Capital Facilities Planning

Addendum 3 – Questions and Answers

To: All Bidders
From: Sayim Malik
Project Manager, Capital Facilities Planning
Re: Project SU-022723 - Phase 3 Bathroom Rehab Project
DATE: JUNE 26, 2023

Title	Date
PHYSICAL EDUCATION - ELECTRICAL PLANS	06-15-2023
	Project No. 1944
	Drawing By LJ
	CHK By SM
	Scale AS NOTED
	DOB Rev
	E-101.00

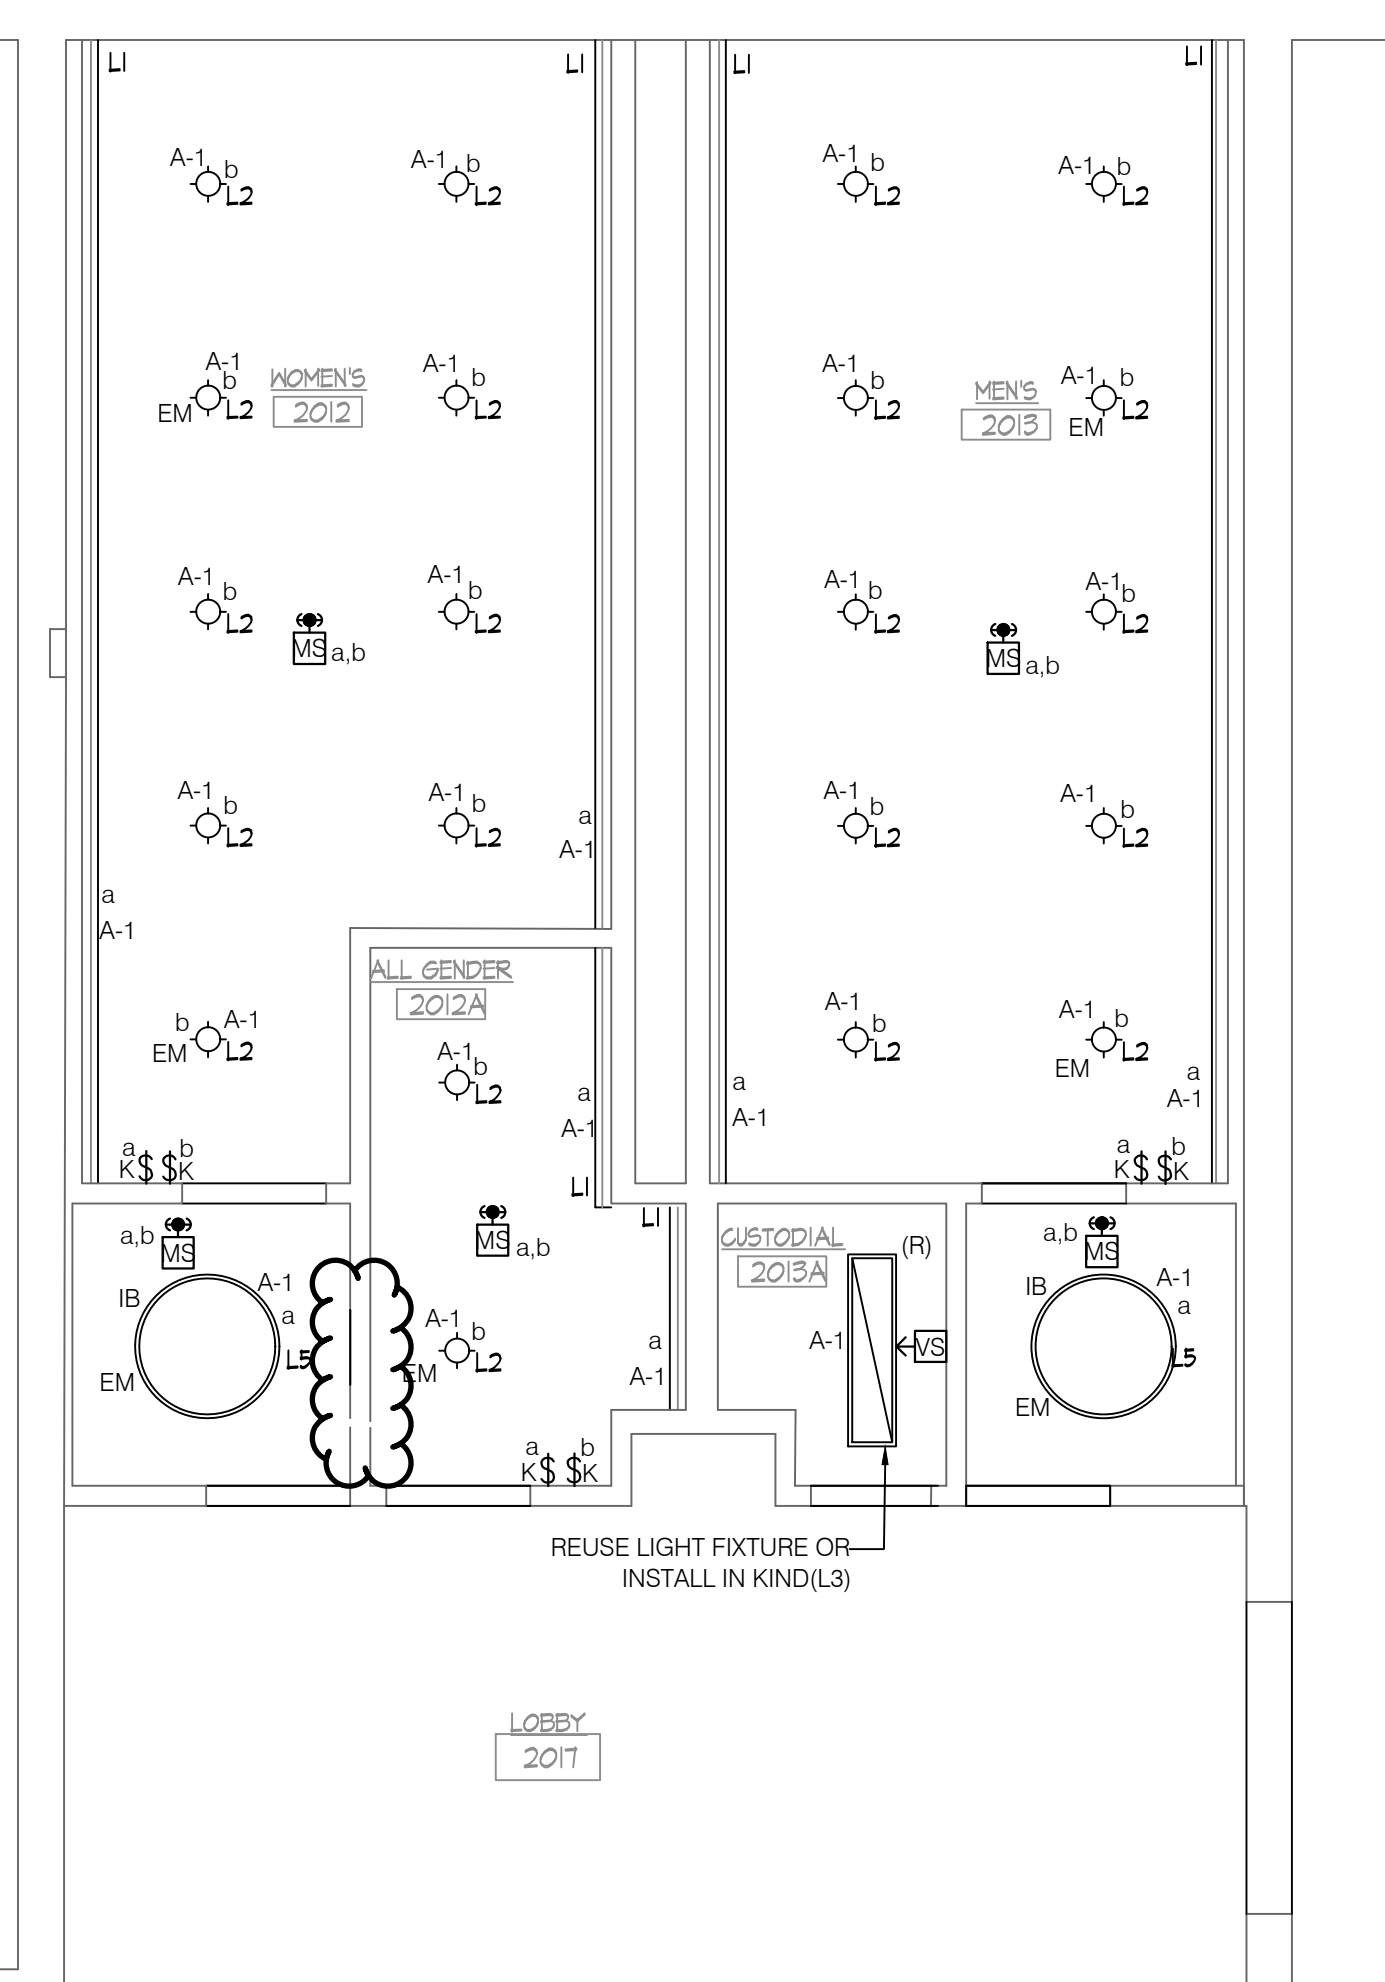
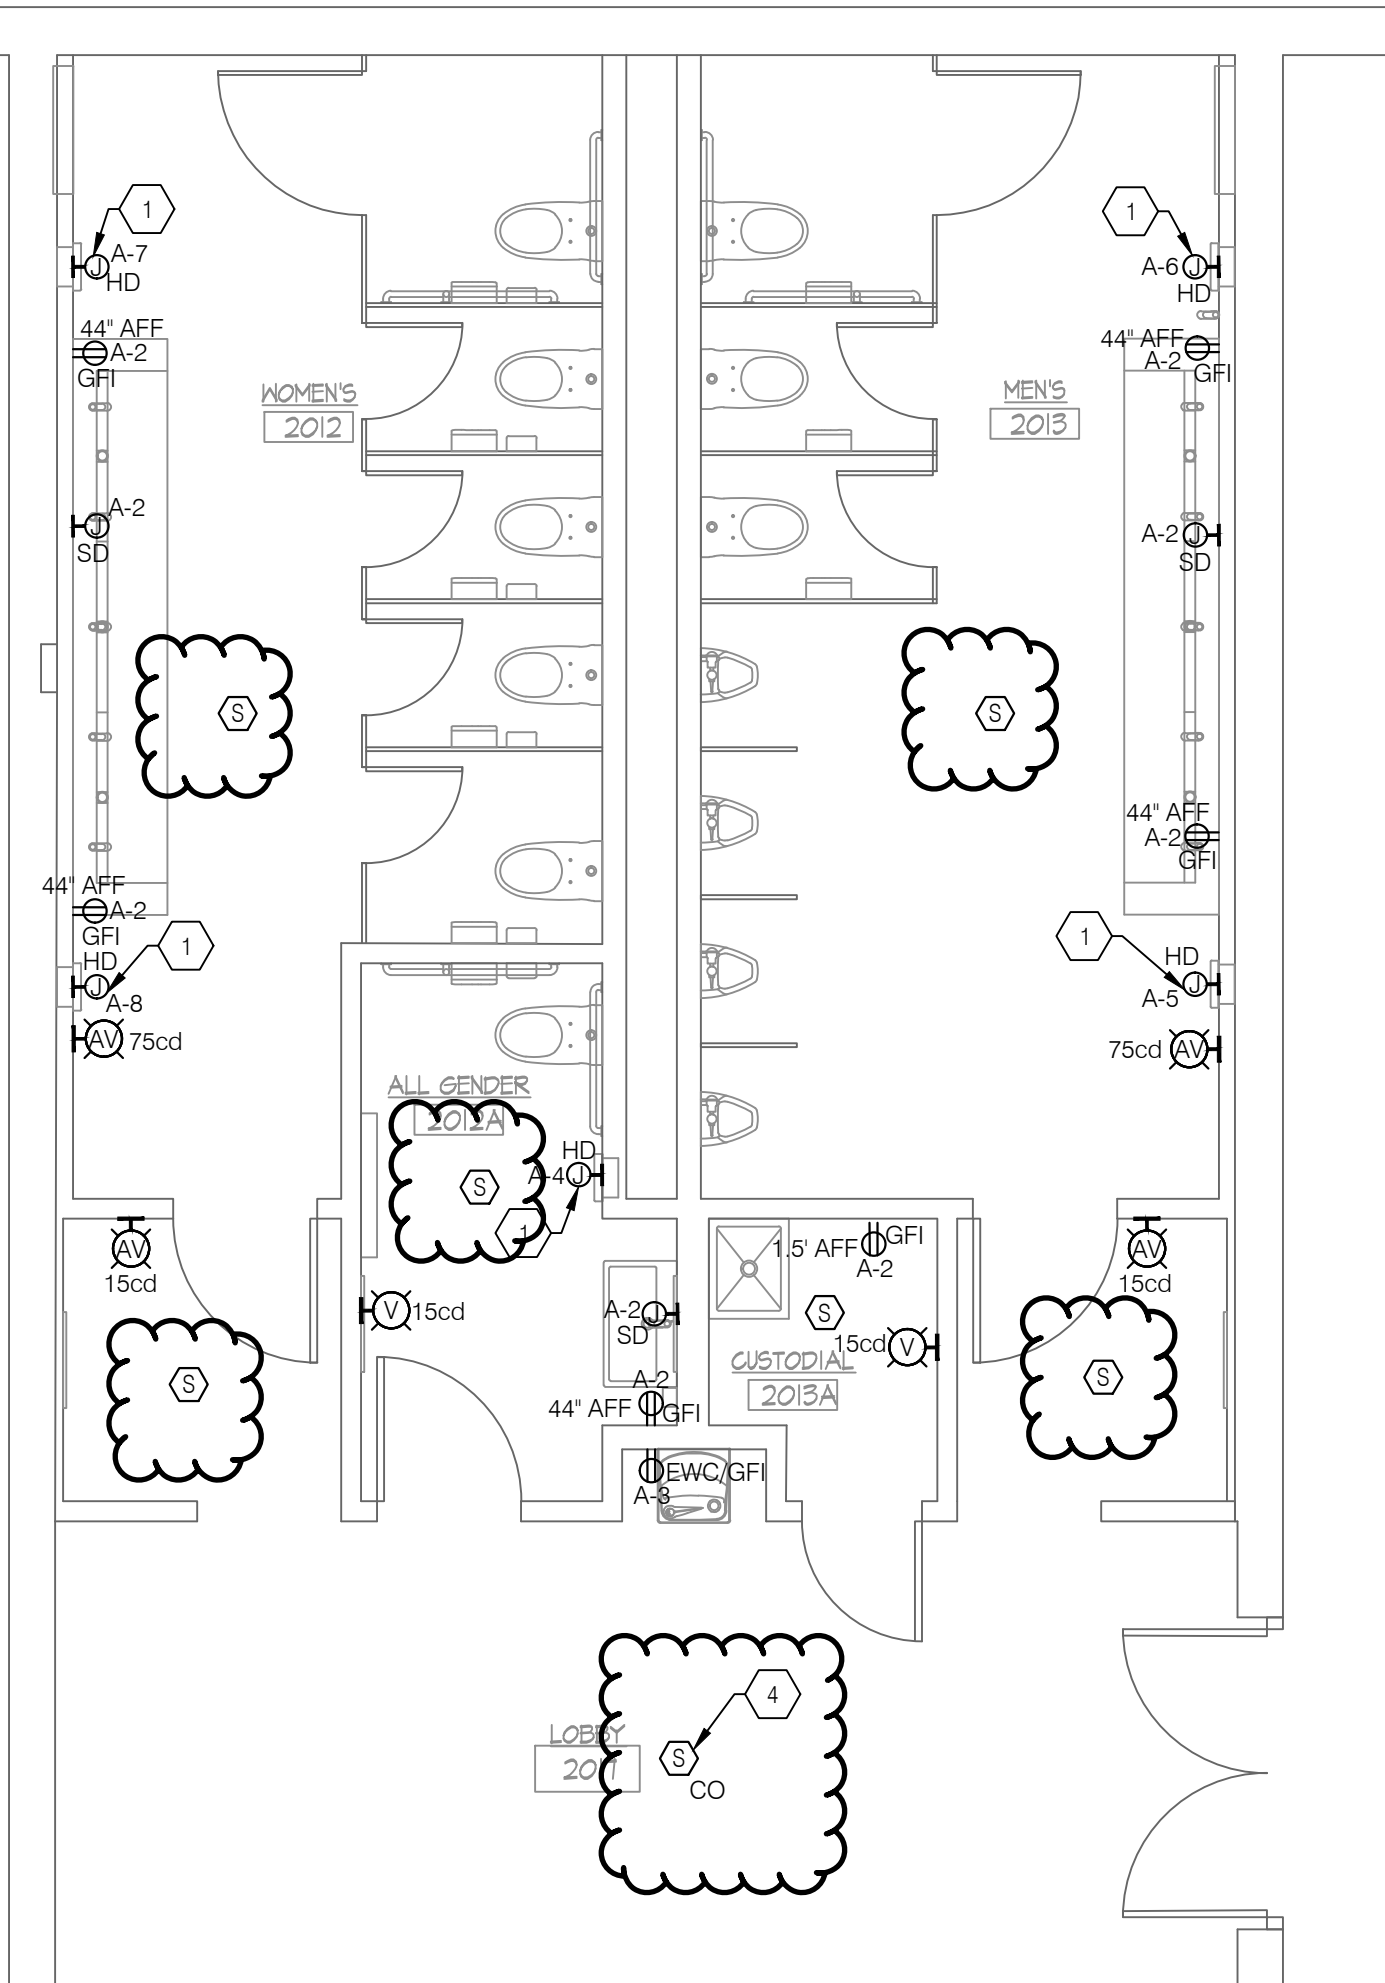
Question 6: Physical Education Building: provide a Key Plan to Scale showing the Area of Work and the Electrical Closet.

- Question 10: Drawing E-101.00 Detail #3 First Floor Lighting Plan Sheet Key Note #2 calls for one (1) 50-watt Inverter yet the Type L5 light fixtures are 75 watts each. Are additional Inverters required and what power requirement?

Answer 6: *Key plan is indicated in the title-block on this sheet. Electrical room has been called out for reference. Refer to E-101.*

- Answer 10: *Please note this fixture has been specified with EM battery backup option.*
- Question 11: Drawing E-102.00 Detail #3 First Floor Lighting Plan Sheet Key Note #2 calls for one (1) 50-watt Inverter yet the Type L5 light fixture is 75 watts each. Are additional Inverters required and what power requirement?
